Report Date: May 3, 2023

Report Number: 199722

Cutline Industries Ltd. and 1064413 B.C. Ltd. doing business as LifeSoils Products
680 McKenzie Road Abbotsford BC

Re: An Administrative Penalty Referral

Photo 8. View of Leachate Discharge on the Southeast Side of the Facility (as indicated by the orange arrows).

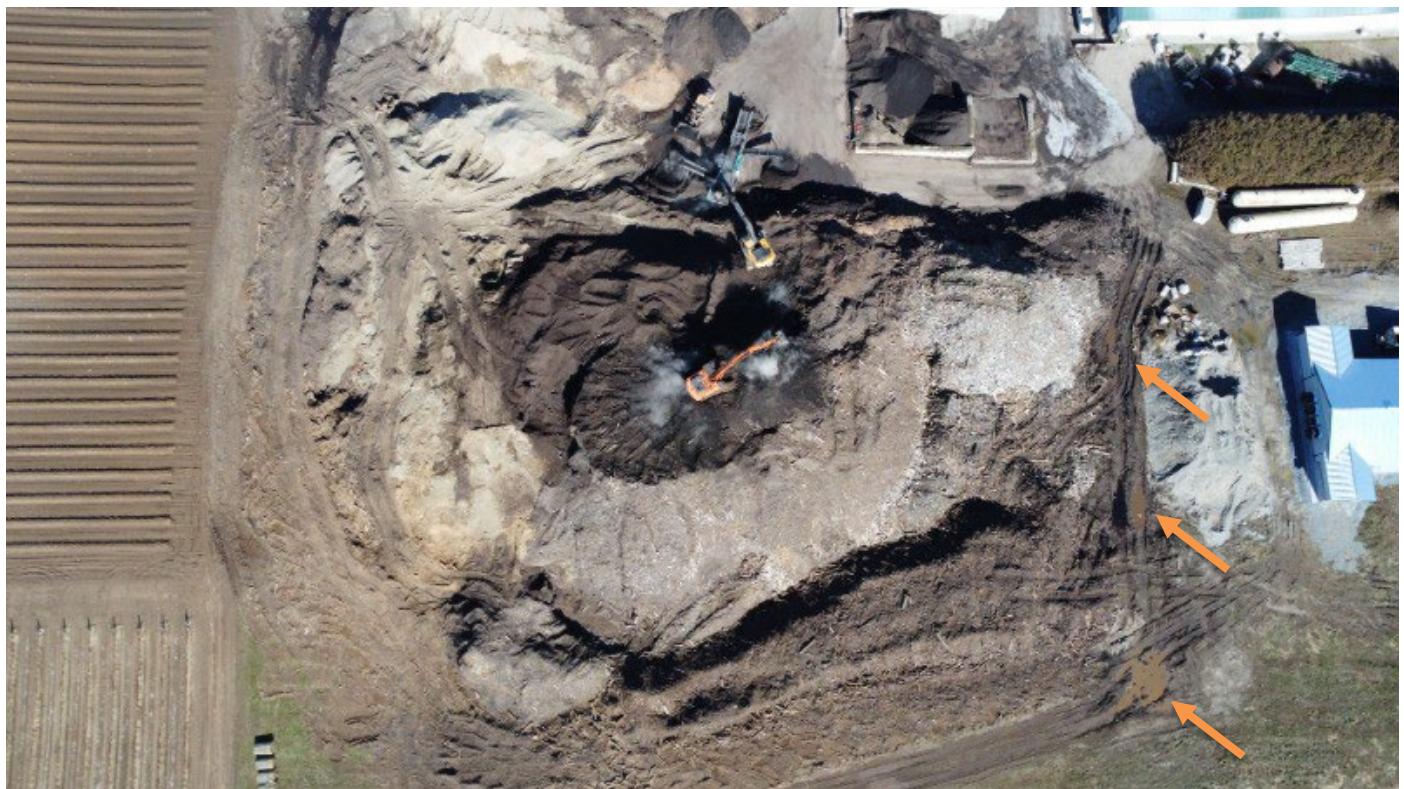
Actions to be taken:	Ensure that a leachate collection system has been designed, constructed, maintained, and operated to rescue leachate or to remove leachate from the receiving, storage, processing and curing areas.
Requirement Description:	<p>Environmental Management Act, Organic Matter Recycling Regulation (18/2002) (EMA)</p> <p>26 (3): Leachate that is not collected and reused in the composting process must not be discharged into the environment unless authorized under the Act.</p>
Details/Findings:	<p>Since the previous inspection (IR#182205), the Senior Environmental Scientist informed Officer Angus that the stormwater collection sump had been filled in. The Senior Environmental Scientist also informed Officer Angus that water was used to suppress the fires that occurred on October 9 and November 28, 2022, and then the water was subsequently reintroduced into the composting process (IR203661).</p> <p>As identified in previous inspection reports (IR#128402 and IR#182205), there are two mapped aquifers located beneath the Facility that are separated by glacial till but likely to be hydraulically connected. The upper aquifer consists of sand and gravel, has a relatively shallow water table (10 m below ground surface), and is highly productive, with many wells pumping at rates greater than 10 L/s. As such, the aquifer was determined to be highly vulnerable to contamination (Attachments 1 and 2).</p> <p>During the inspection, Officer Angus and Officer Howett observed leachate being discharged to ground near the storage and curing area where concrete was removed, on the west side of the Facility and on the southeast side of the Facility (Photos 7 and 8). No sections in OMRR authorize these discharges, and Officer Angus confirmed that these discharges were unauthorized.</p> <p>The previous IR182205, dated March 7, 2022, determined that LifeSoils was out of compliance with Section 26(3) of OMRR for not collecting and reusing leachate in the composting process and for discharging leachate into the environment. The Ministry response for IR182205 was a Warning.</p> <p>The non-compliance associated with Section 26(3) of OMRR is being referred for an Administrative Penalty.</p>

Compliance:	Out
Actions to be taken:	Ensure that there are no unauthorized discharges of leachate from the Facility to the environment.
Requirement Description:	<p>Environmental Management Act, Organic Matter Recycling Regulation (18/2002) (EMA)</p> <p>27: The amount of organic matter in a composting facility must not at any time exceed the total design capacity of the facility.</p>
